# Simulation details for 4B3T

# Comments on 8B6T with Partial Response

Figure 1

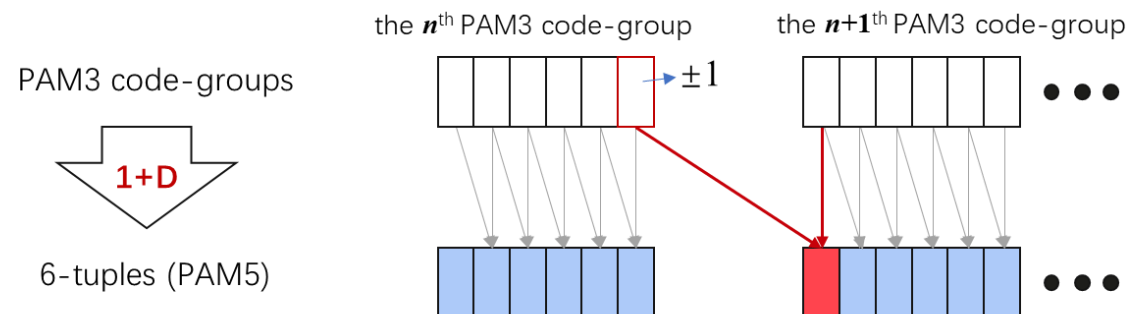
- With 1+D partial response, memoryless mapping only exists between 6T PAM3 and the last 5 symbols of the 6-tuple PAM5 (see Fig.1), while the 1<sup>st</sup> PAM5 symbol depends on the last PAM3 symbol in the previous 6T code-group.

- This indicates that 6T PAM3 or 8bit can be recovered by using only the last 5 symbols of the PAM5 tuple. However, the minimum distance between the last 5 symbols of the 6-tuple PAM5 is 1 not  $\sqrt{2}$ . Therefore, no performance gain.

- There is no restriction on the 1<sup>st</sup> symbol of the 6T PAM3 code-groups, which can be 0, 1, or -1. However, the last symbol CANNOT be 0. Therefore, the 1<sup>st</sup> symbol of 6-tuple PAM5 can be 2, 1, 0, -1, or -2.

- **The number of reference 6-tuples (PAM5) used for Euclidean distance calculation will be 430 or 430\*5**, depending on whether the last symbol of previous 6T code-group is used for ML detection or not.

- For each received 6-tuple with noise, every Euclidian distance calculation needs 6 multiplication. Even with 430 reference 6-tuples, 2580 multiplications are needed. **The decoding complexity is more than two times higher than digital Echo cancellation.**
